IN THE UNITED STATES PATENT AND TRADEMARK OFFICE

In re application of : **Confirmation No. 6208**  
Mitsuaki OSHIMA et al. : Docket No. 2000\_1391  
Serial No. 09/680,177 : Group Art Unit 2634  
Filed October 5, 2000 : Examiner A. Le  
COMMUNICATION SYSTEM :

**LETTER RE PROPOSED DRAWING AMENDMENTS RECEIVED**

**FIG. 10**

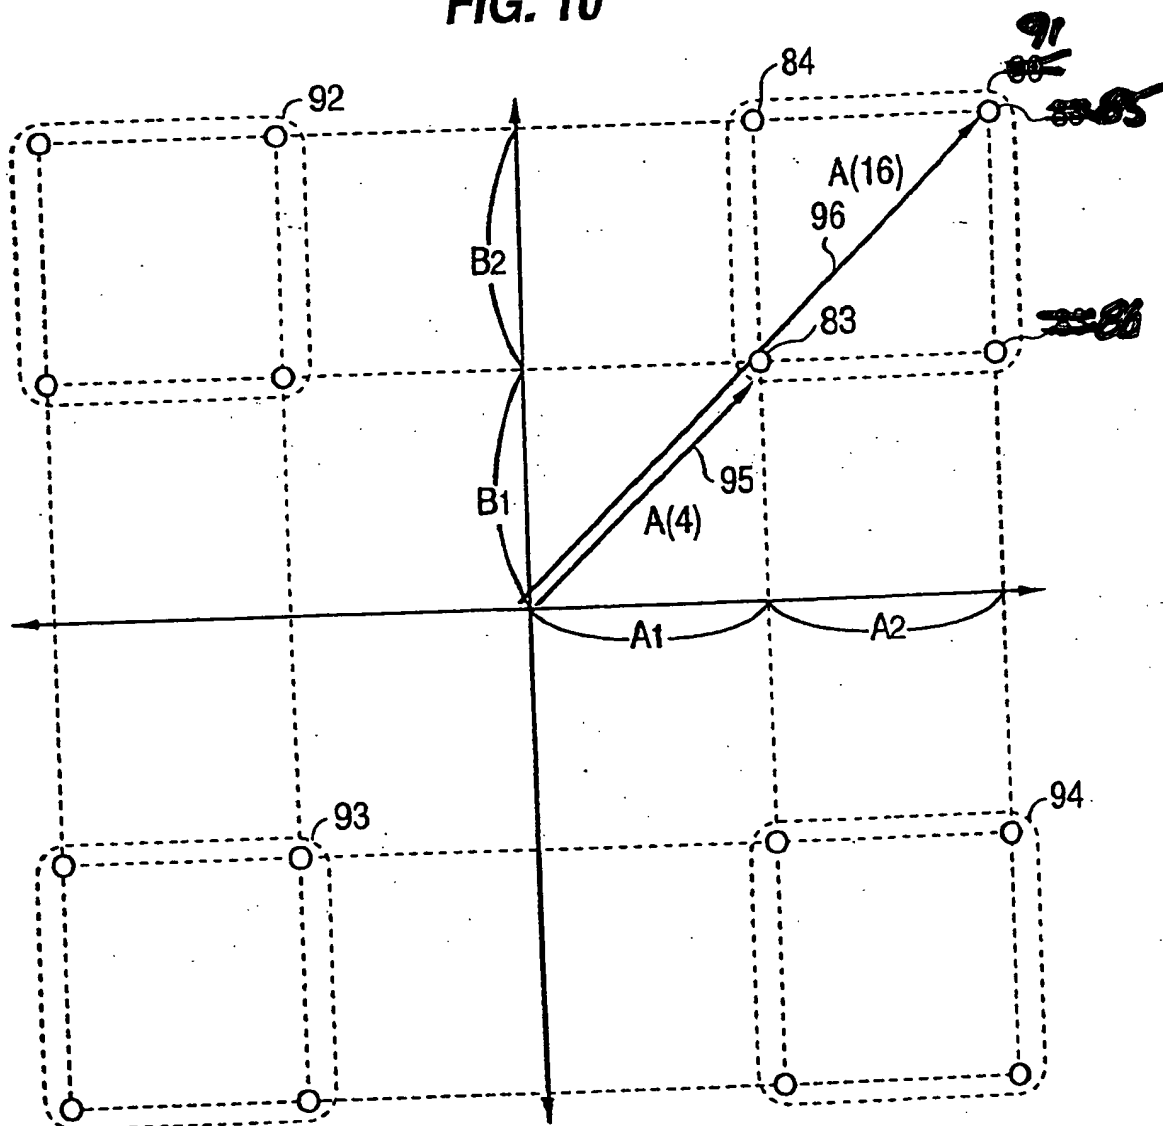
Enclosed herewith is a photocopy of Figs. 2, 10, 17, 29, 48, 65, 67, 93, 112, 131, 138, 144, and 169 marked in red to indicate proposed drawing amendments thereto.
